MAINE YANKEE ATOMIC POWER COMPANY •
ENGINEERING OFFICE

January 20, 1981

Subject: Mitigating the Effects of Grid Degradation on Safety-Related
Electrical Equipment

FIGURE 1

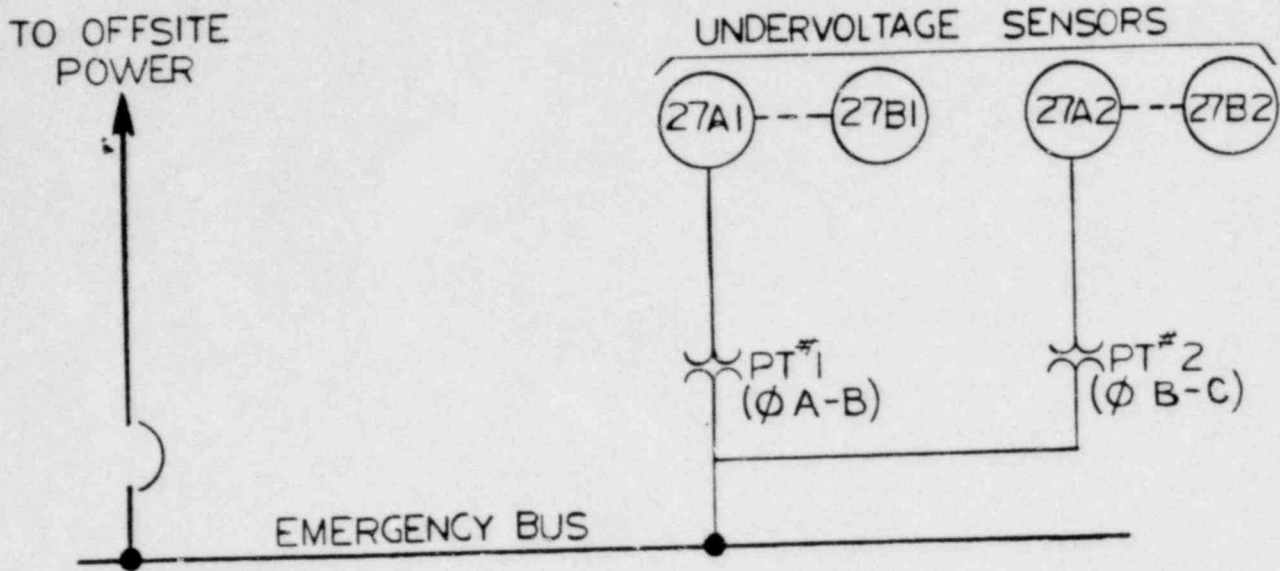
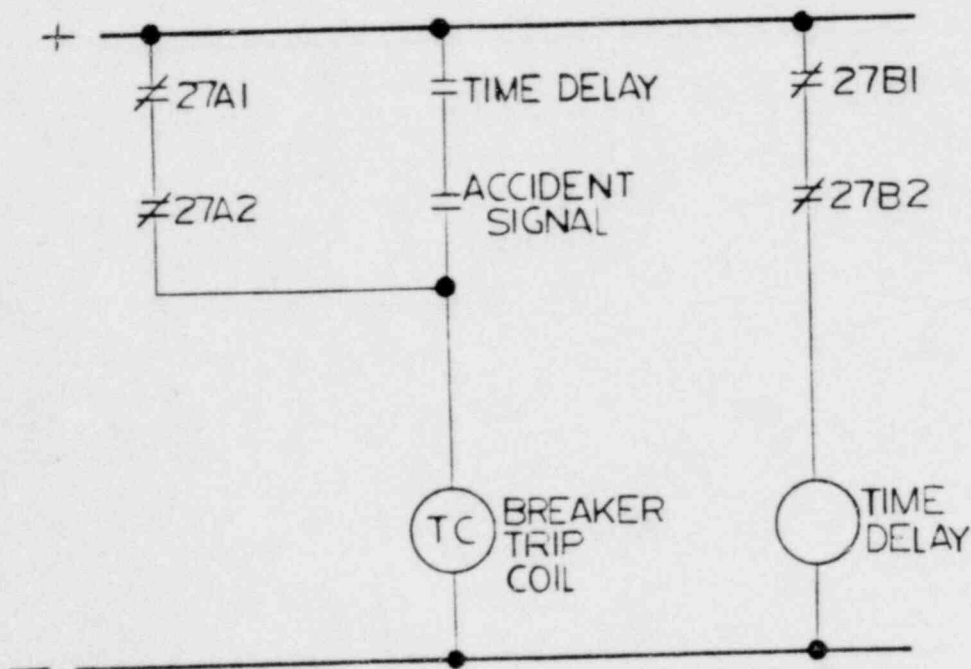
Staff Position 1 of Reference (2) requires coincident logic in the voltage protection scheme to preclude spurious trips of the offsite power source. The proposed logic in Reference (6) does not preclude spurious trip of offsite source in all cases and, therefore, the required coincident logic should be provided in accordance with Table 3.3-3 in Enclosure 2 of Reference (2).

YAEC proposes to modify its design to include coincident logic. Two second level undervoltage relays will be added to each safety bus: Each second level undervoltage relay will be supplied from an independent instrument transformer. The circuit breaker connecting offsite power to the emergency bus is shown in Figure 1. The first level undervoltage relays are shown as device 27A-1 and 27A-2. The second level undervoltage relays are shown as device 27B-1 and 27B-2.

When voltage is degraded below that required to ensure continued operation of safety-related equipment, the second level undervoltage relays 27B-1 and 27B-2 will be activated. Contacts of the second level undervoltage relays will close in the breaker trip circuit as well as in the alarm circuit. The contacts in the breaker trip circuit are arranged to provide 2 out of 2 coincident logic and the breaker will trip automatically if an accident signal is also received. The contacts in the alarm circuit are arranged to provide 1 out of 2 coincident logic.
